## SERVICE LETTER 200

### 8750A BRAKE LINE REROUTE

Aircraft Makes/Model(s):	Float Model(s):	Compliance: Recommended	By: MAS
208 and 208B	8750A	Part Number: 1011104	Approved: DRH
		Date: 5/23/2024	Revision: C

**Figure 1**

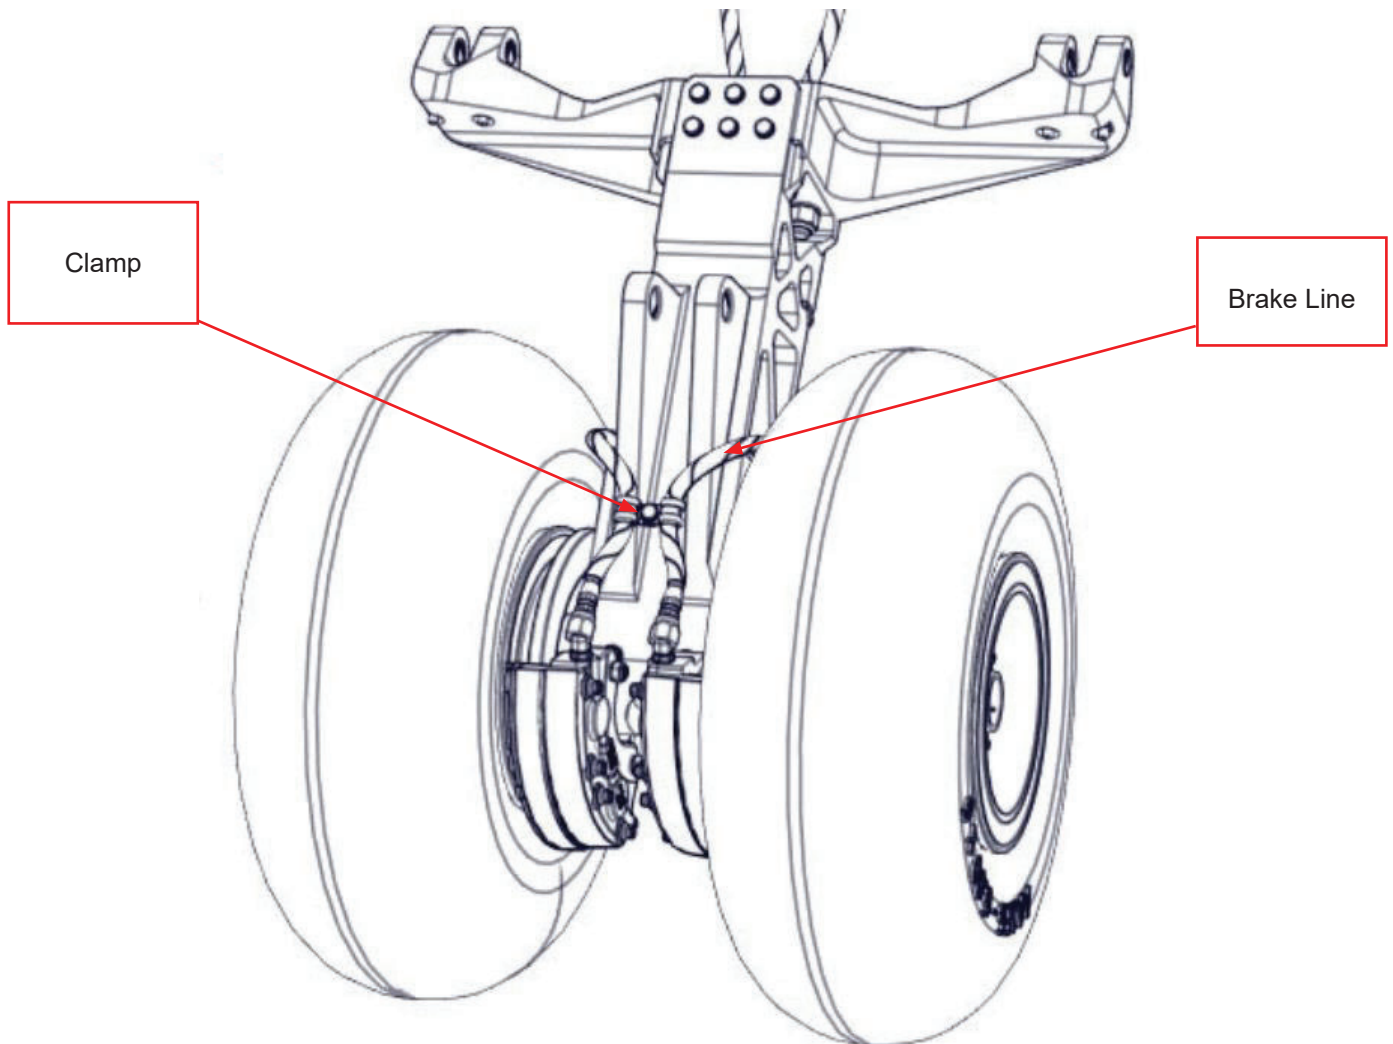
Brake lines are chaffing against the drag brace causing the metal to corrode. This service letter provides an option to reroute the brake line and reduce further chaffing.

**Brake Line Routing Prior to  
Service Letter**

Drag Brace  
Chaffing Area

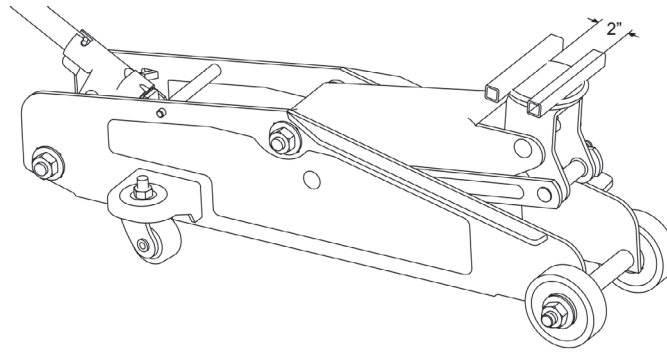
The Main Gear Drag Brace is chaffing due to the brake line rubbing against it during daily use. This service letter reroutes the brake line to avoid further wear.

Prior to brake line reroute, inspect chaffing on drag brace. Chaffing should not exceed 0.200" in depth. Damage within tolerance should be refinished and blended at a 20:1 width:depth ratio, or as best as practical per technician's discretion in order to prevent corrosion. Damage exceeding 0.200" in depth will need a new drag brace to perform the work in this service letter.

**Figure 4**

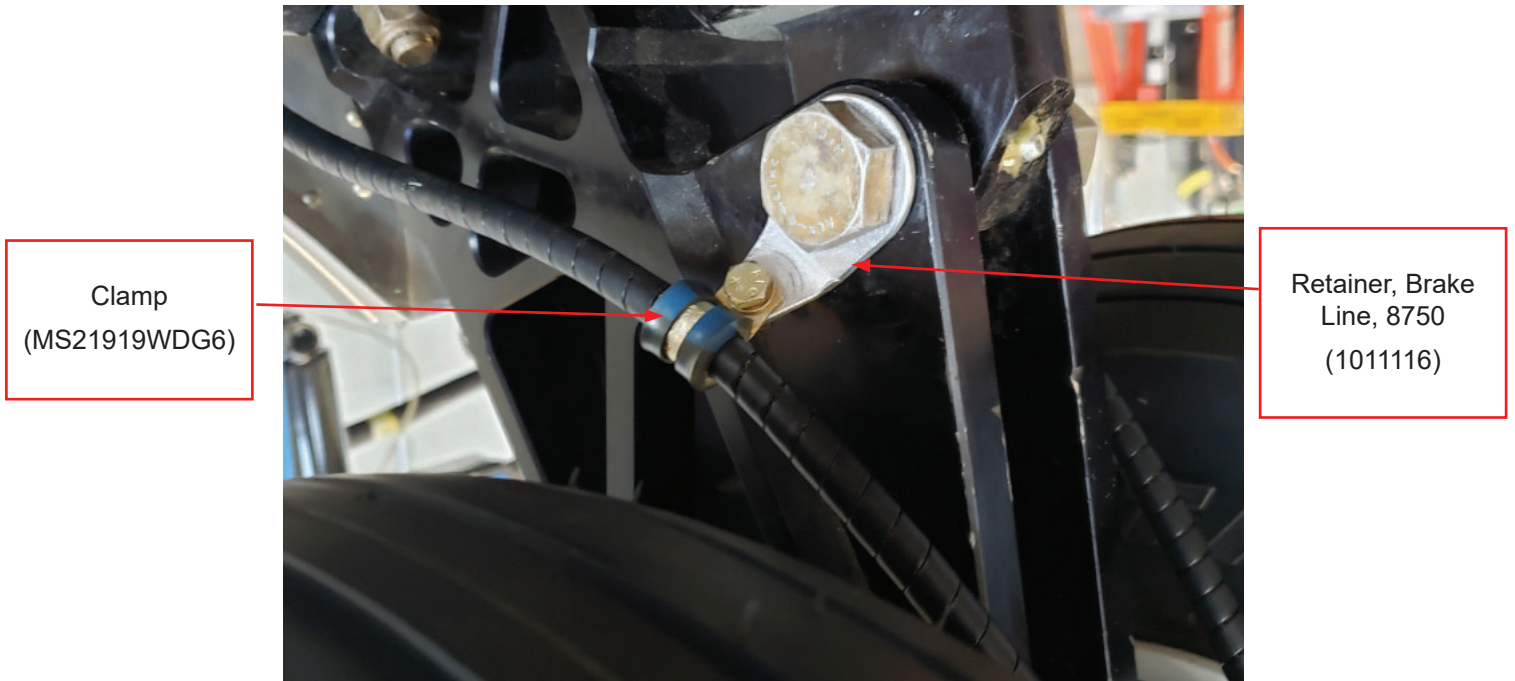
1. Remove brake lines from "T" fitting.
2. Pull brake lines through drag brace.
3. Secure drag brace so that oleo attach bolt (AN12-35A) can be removed.
4. Remove standard washers, replace with brake line retainer (1011116), treat with Tef-Gel.
5. Install nut and torque accordingly.
6. Attach brake line using adel clamp (MS21919WDG6) with provided hardware as shown in Figure 4.

**Note:** Position retainer so it avoids brake line contacting the landing gear.

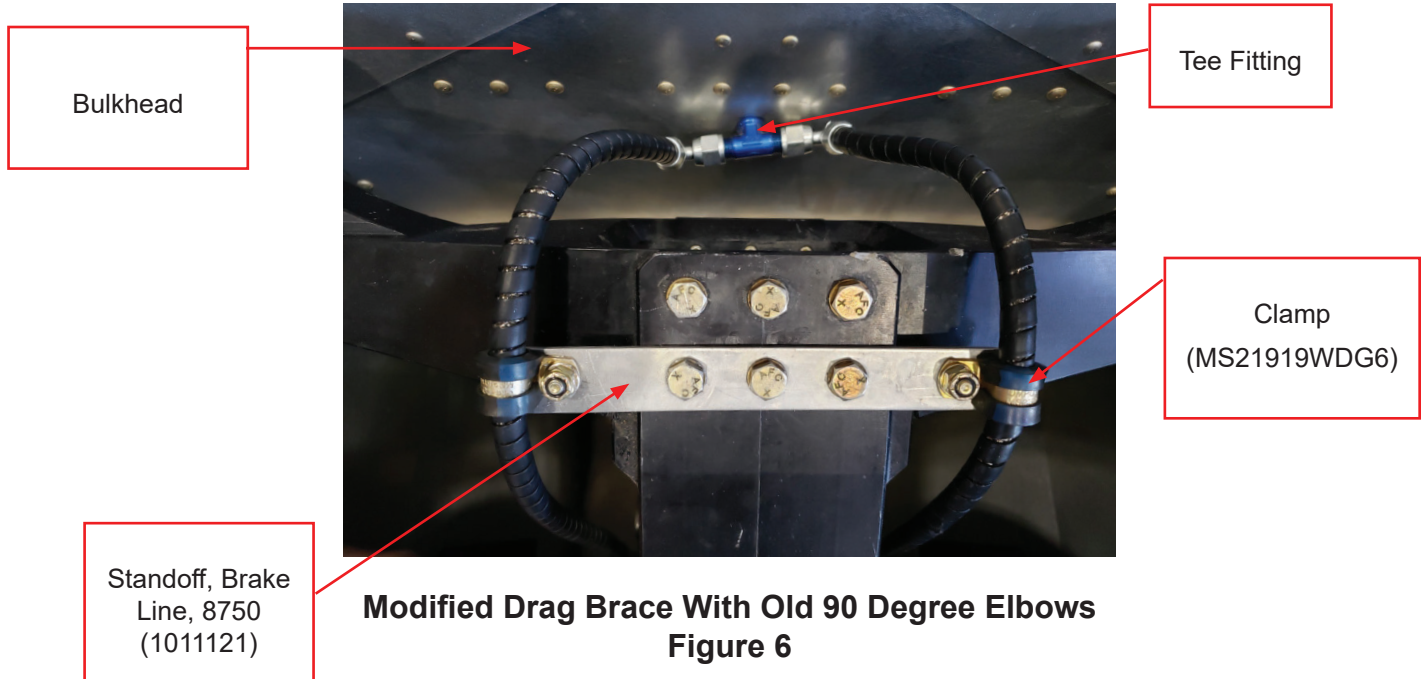
7. Remove bottom bolts (AN4-5A) from drag link.
8. Install new Standoff, Brake Line (1011121) on drag link, treat with Tef-Gel between the two surfaces, replace AN4-5A with AN4-6A. Install bolt with Loctite Threadlocker Blue 242 or equivalent.
9. Install adel clamps (MS21919WDG6) on brake line. Attach to the standoff.

**Figure 8**

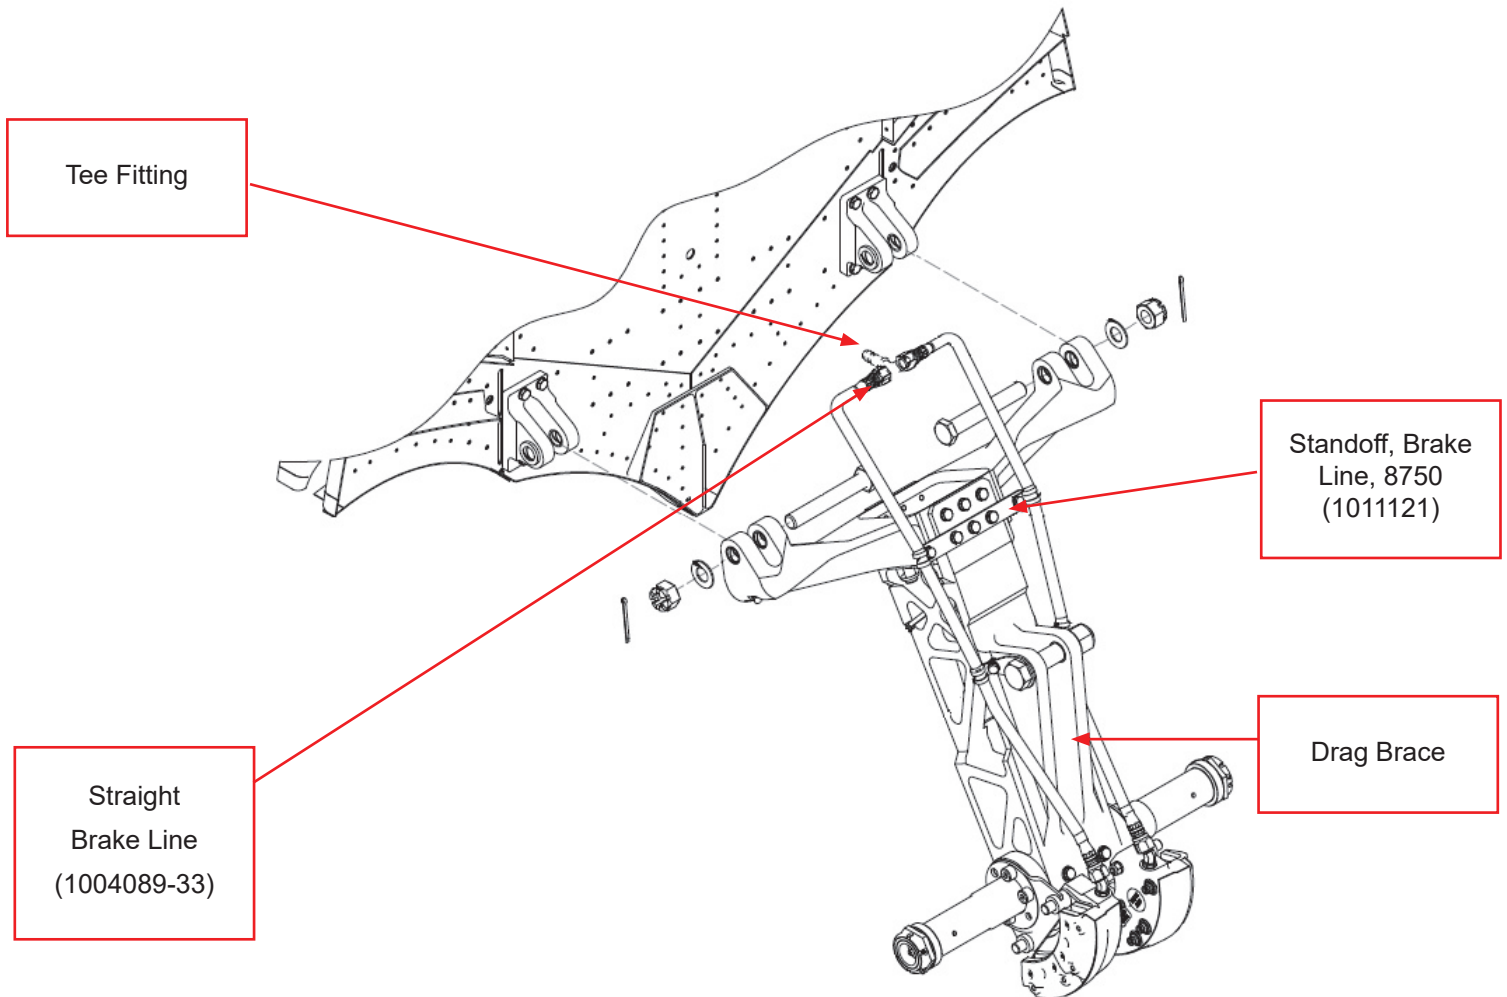
13. Confirm brake line doesn't rub anywhere along the drag brace. If it does, realign the brake line.
